**Change Order Request No. 01**

**Reference:** City of Rochester Hills, Masonry Screen Wall and Gate Replacement Project  
Auch Project No. 8943

**BULLETIN #1**

Project: Rochester City Hall Masonry Screen Wall Replacement and Compound Gate Replacement

## C101

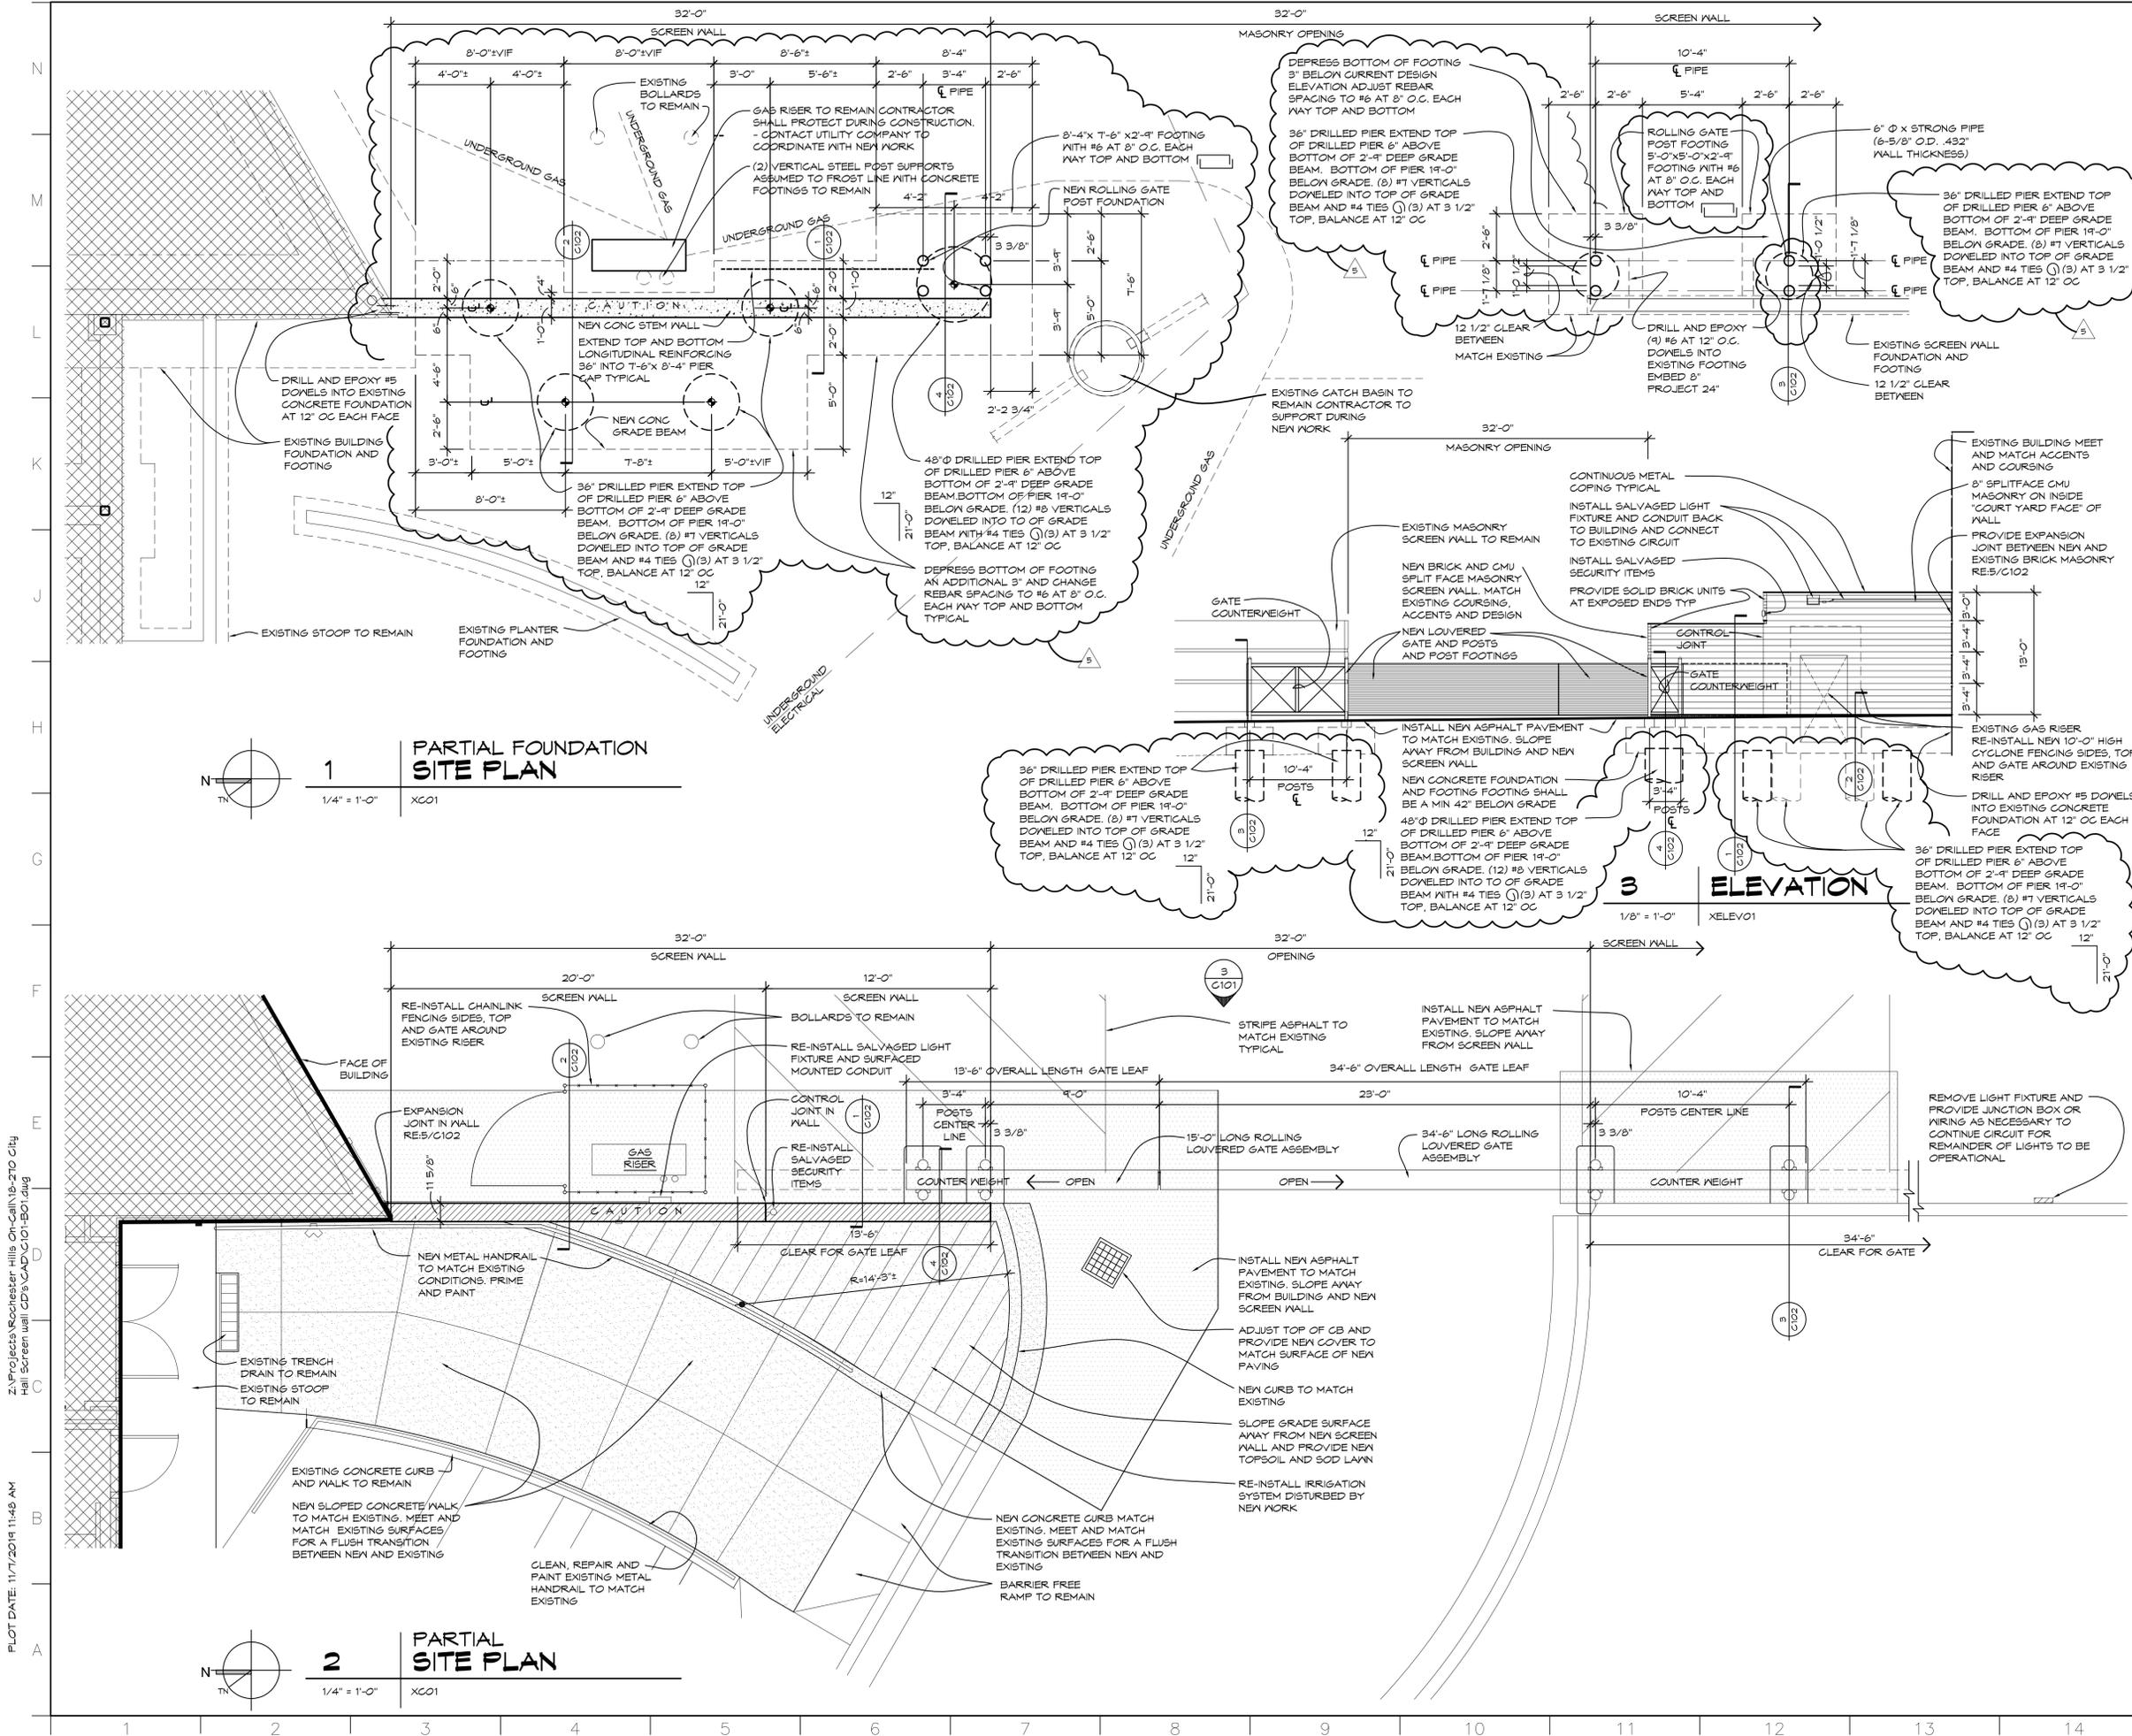
- Item #1: Refer to attached
- a. Drawing C101 and C102 sealed and signed for foundation adjustments due to poor soil conditions.
  - b. Structural calculations.

Therefore I have re-designed the screen-wall foundation as a grade beam supported on drilled piers and have transmitted that design to H2A for final drafting as can be seen on the attached drawings.

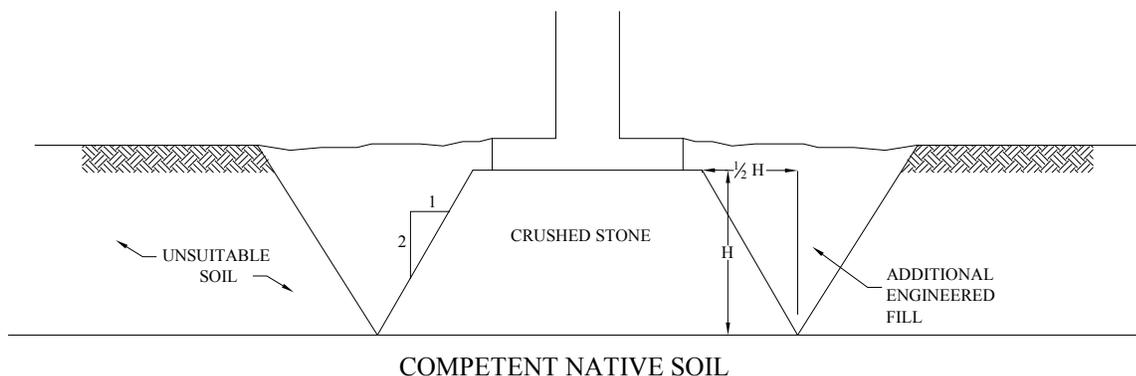
Once the voids are filled with the 6A aggregate the foundation area should then be cut to design grade and the bearing capacity at invert level confirmed by TEC. If the subgrade is soft and does not meet the required bearing capacity the contractor should be prepared to undercut about one foot and replace it with 9 inches of lightly compacted 1x3 inch crushed aggregate choked off on the top with 3 inches of compacted 21AA aggregate. The compacted aggregate should extend outside the foundation dimensions at least one half the thickness of the aggregate thickness below the foundation where possible as shown in the sketch below.

**TEST BORING LOCATION PLAN**

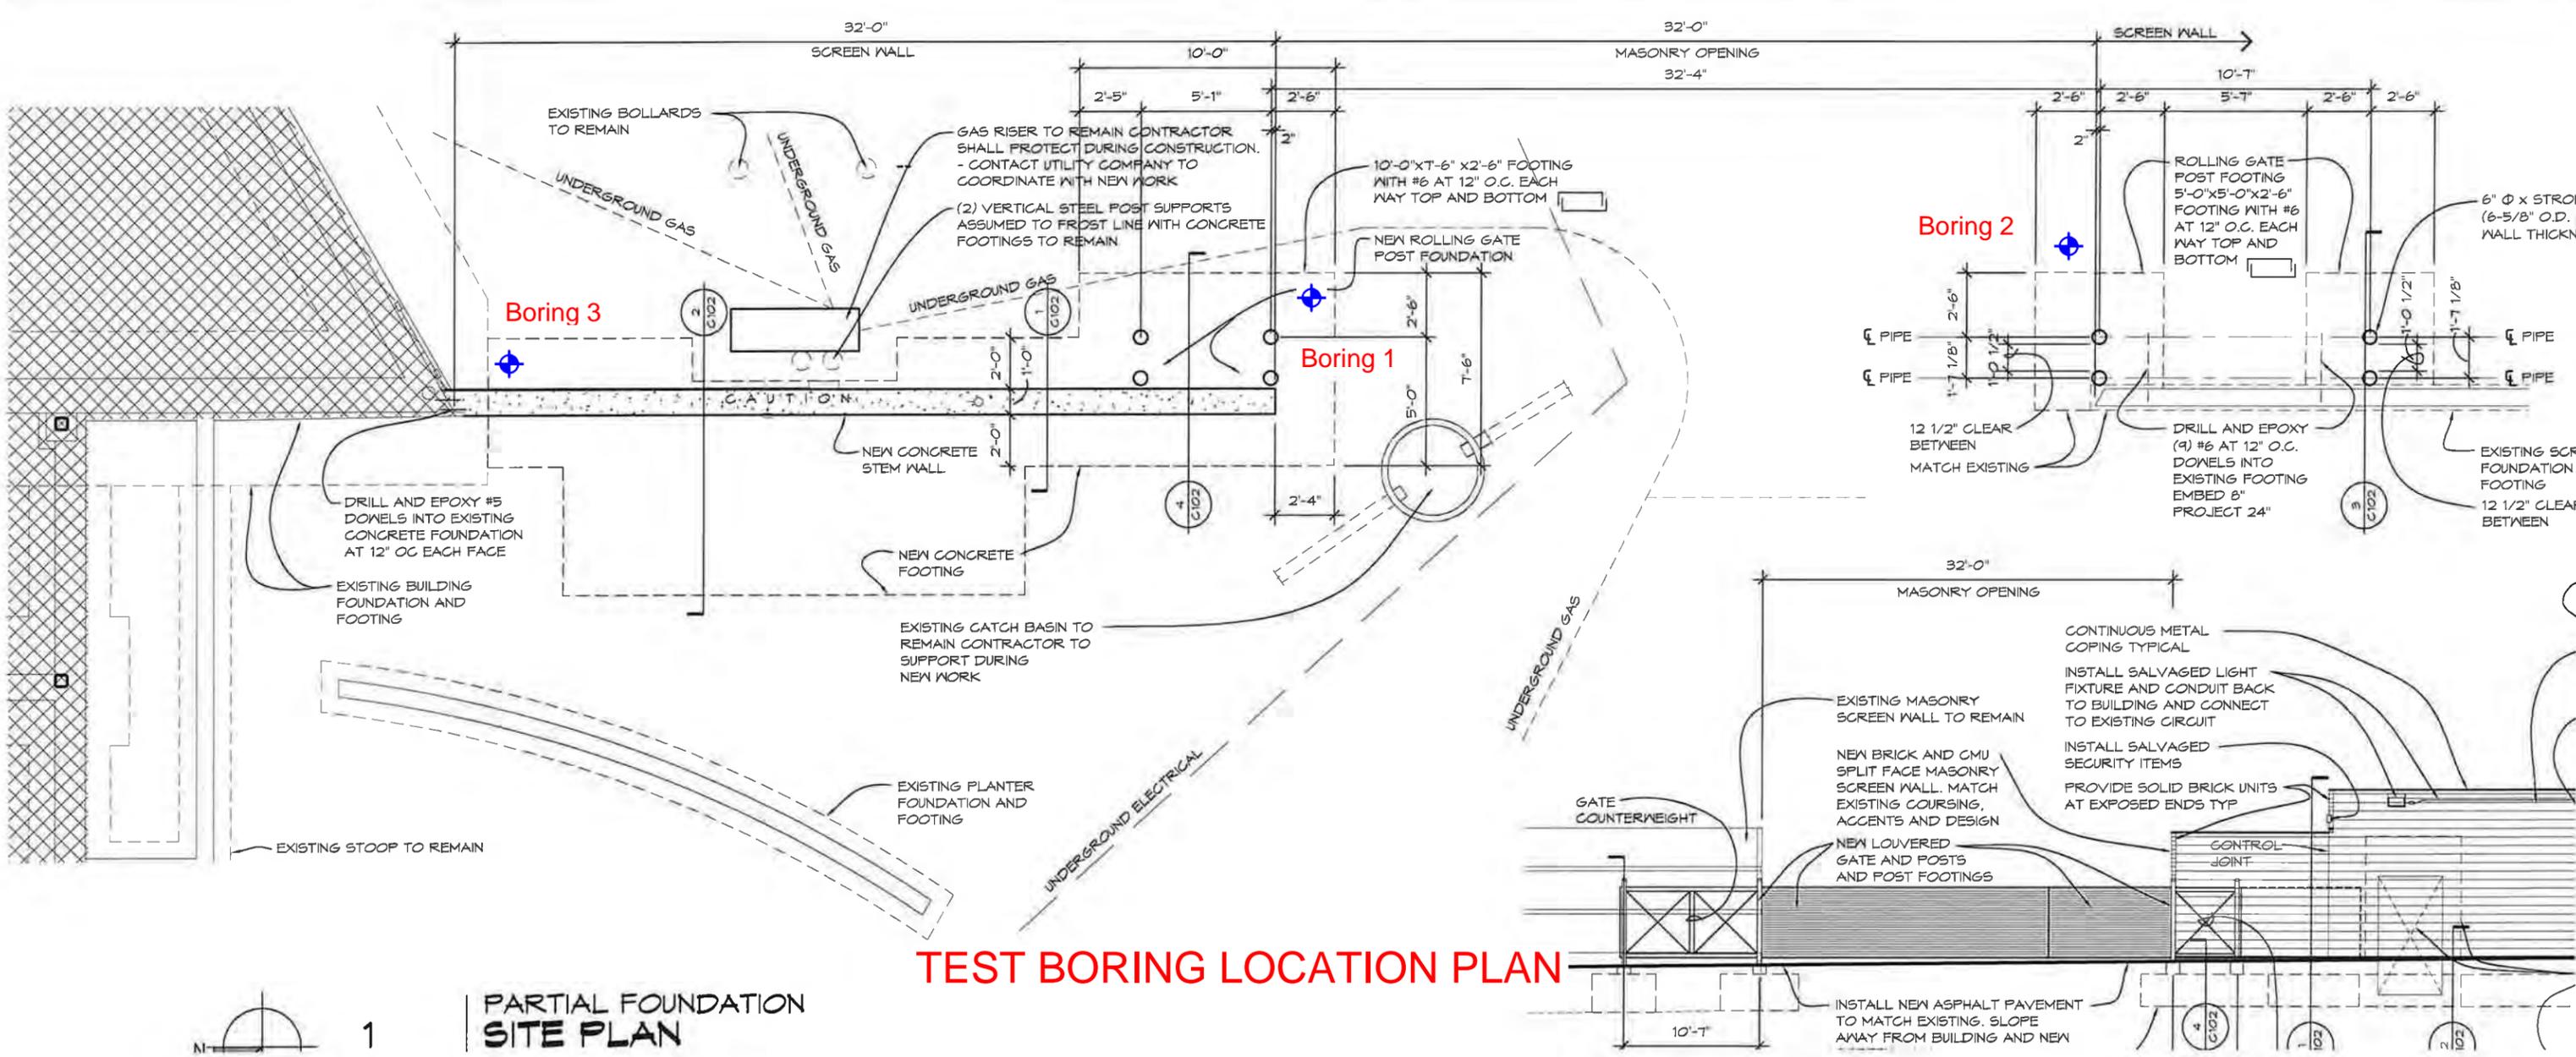
The contractor began excavation for the new foundations for the above referenced project. The soils were found to be soft and wet. Furthermore, it was discovered that the gate structure had been supported on 2 ½ foot diameter concrete piers with an outer corrugated metal casing. The piers were pulled out and they were about 15 feet long. To address the questionable soil conditions we performed three soil borings. Two borings were drilled to 25-foot depth, and one boring was drilled to 15-foot depth. The boring locations are shown on the attached drawing.
